MARQUETTE CITY PLANNING COMMISSION
Tuesday, June 03, 2025, at 6:00 p.m.
Commission Chambers at City Hall – 300 W. Baraga Ave.

TO: Planning Commission
FROM: Andrea Landers, Zoning Official
DATE: May 28, 2025
SUBJECT: 01-PUD-03-25 (05-SPR-06-25) – Preliminary PUD plan review for W. Magnetic St (Portion of PIN: 0410681))

Project/Application: Preliminary PUD Approval and Site Plan Review for a proposed Planned Unit Development (PUD) for a mixture of Townhome types (one-unit, duplex, triplex, and six-unit) for a total of 36 units to be located at the three existing parking lots on the south side of W. Magnetic Street between Lee Street and Fourth Street.

TO: Andrea Landers
FROM: Jeff Fossitt
DATE: 04-28-25
SUBJECT: 05-SPR-06-25 and 01-PUD-03-25
Parcel Numbers: 0410681
Magnetic Street

LANDSCAPING TOTALS:
DECIDUOUS/EVERGREEN: 11
ORNAMENTAL: 4
SHRUBS: 62

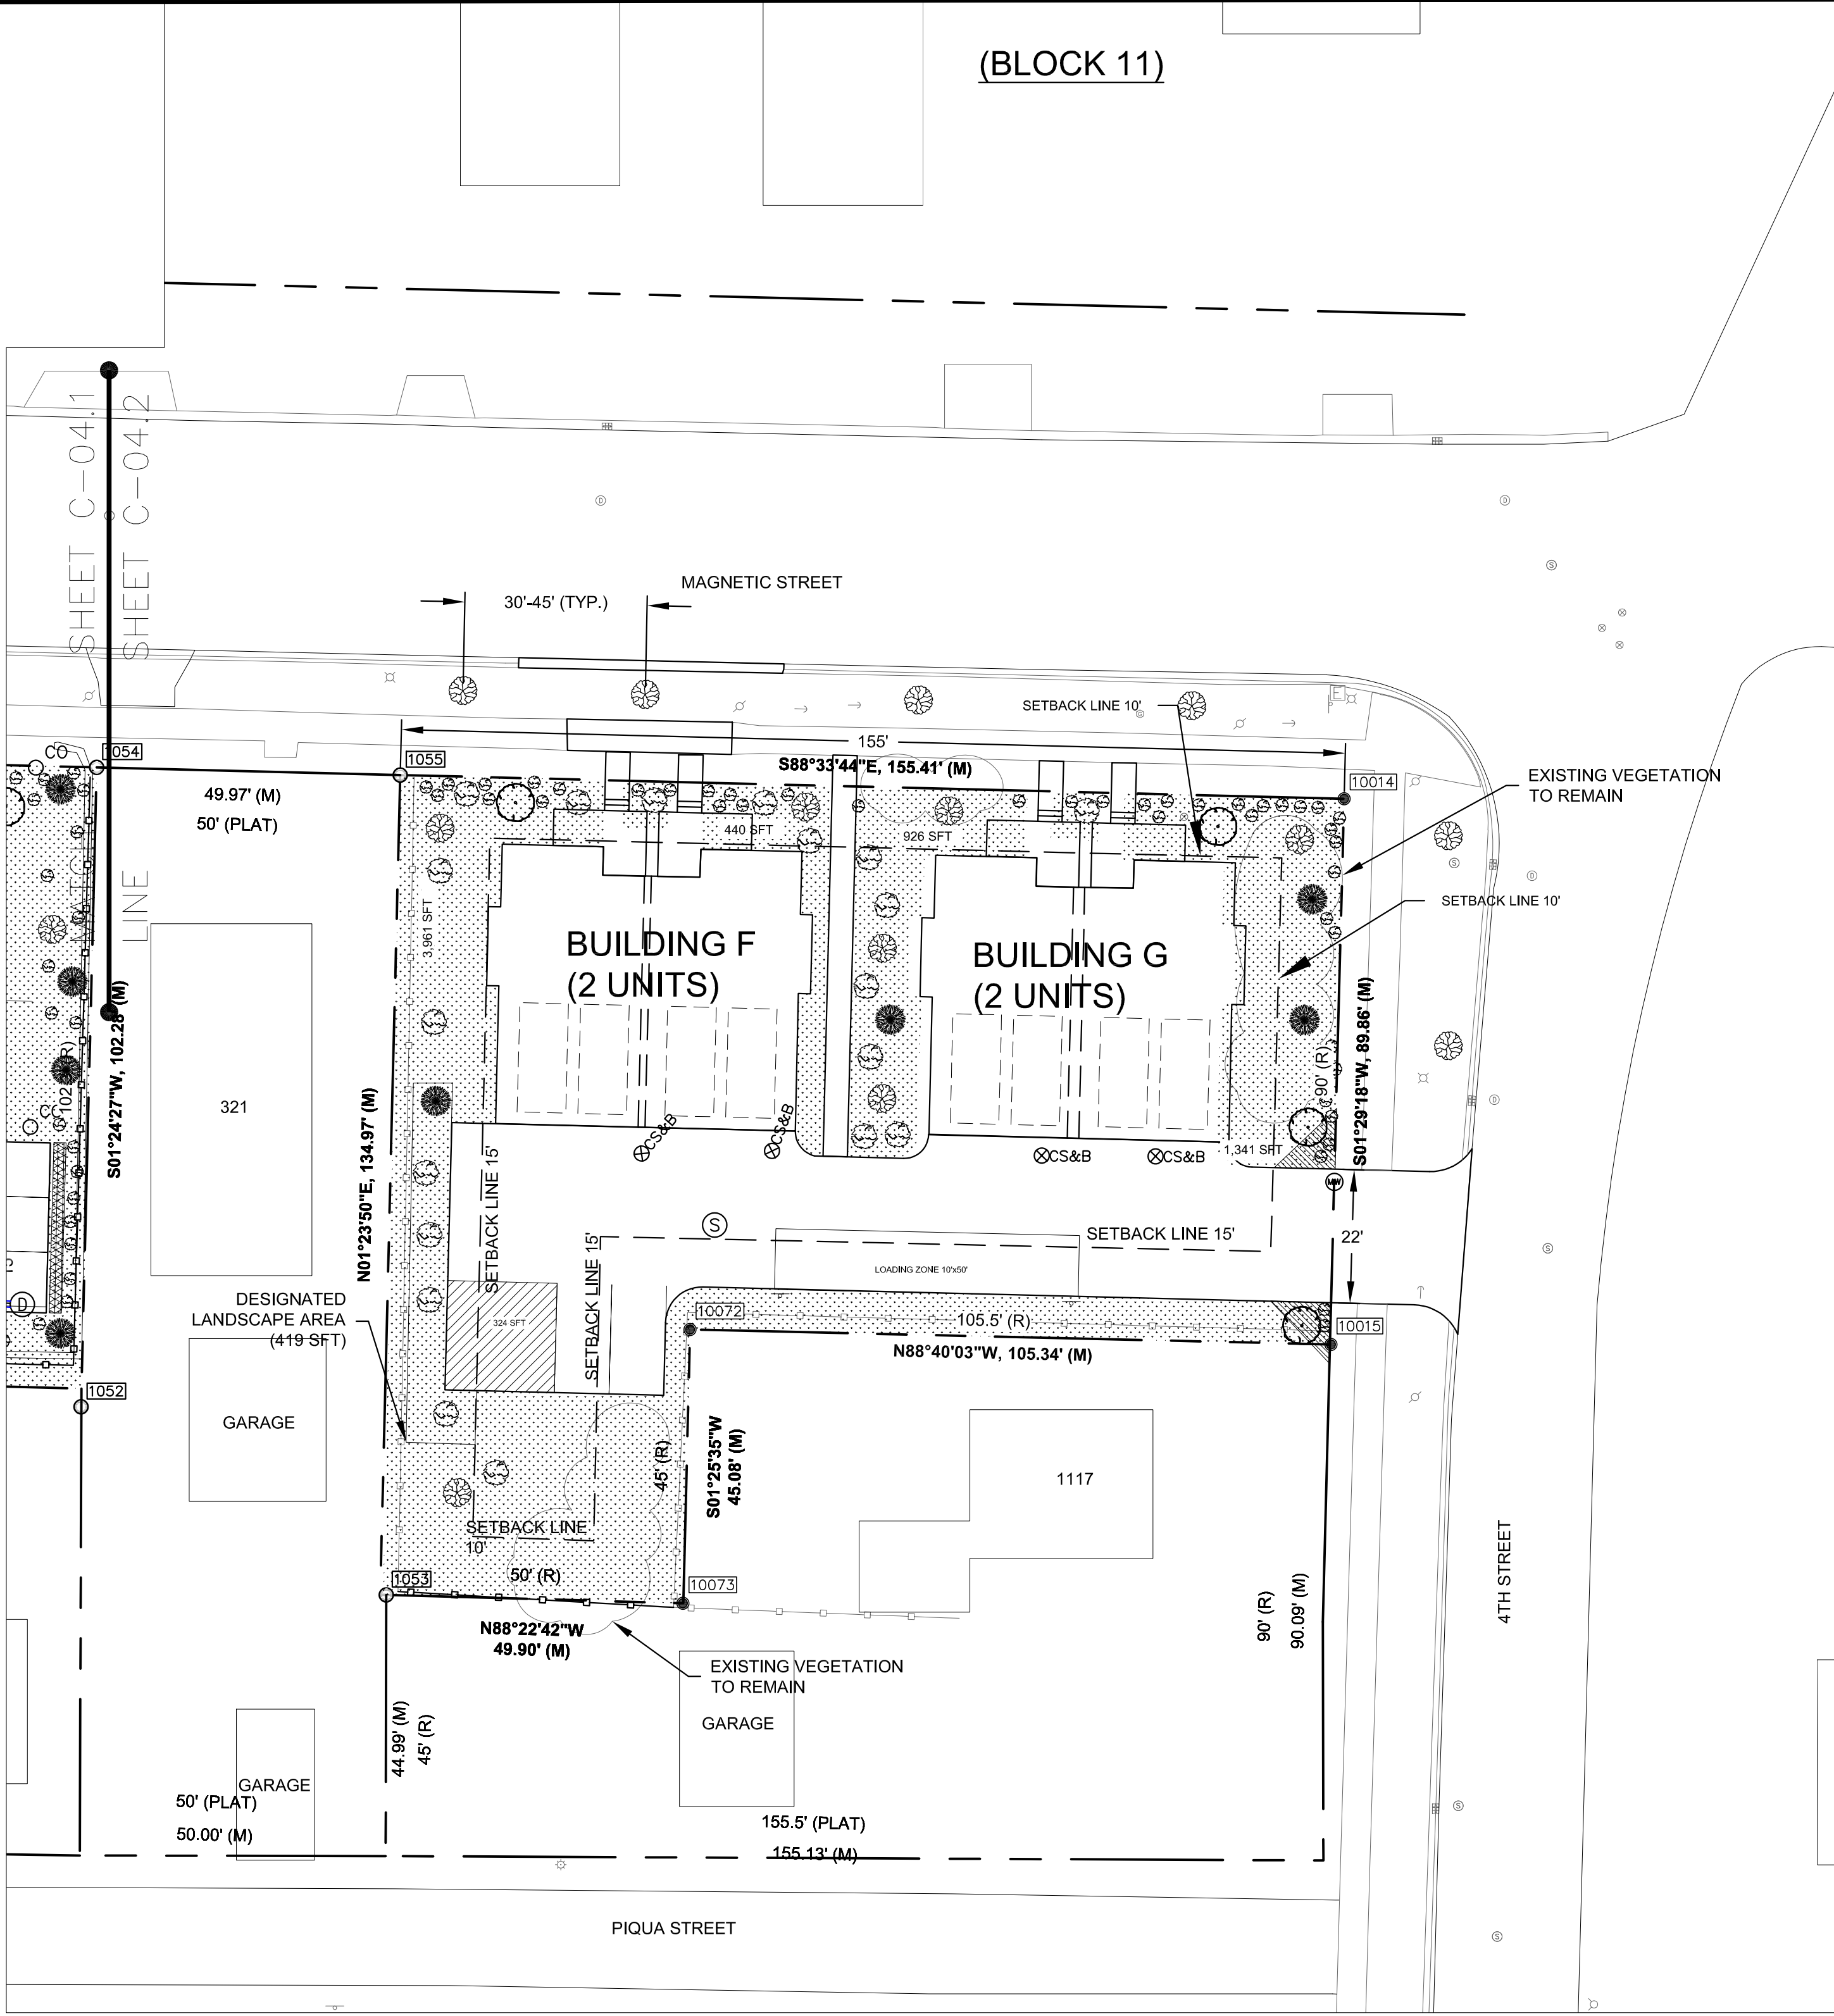
See Sheets C-04.1 and C-04.2 for the landscaping plan. Please see Zoning comments and applicant's responses regarding the proposed landscaping for the site.

- **Section PUD (H)(1)(K) – We have Added Notation to the Landscape Plan sheets C-04.1 and C-04.2 indicating that all of the Green Area and Buffer Yard Landscape areas will be permanently preserved, and the Condominium Association will be responsible to provide annual maintenance of these areas and provide re-planting as necessary.**

- **On Sheet C-04.1 we have also added notation that the large green space including the proposed Pavilion will be permanently preserved area for the entire Condominium Association.**
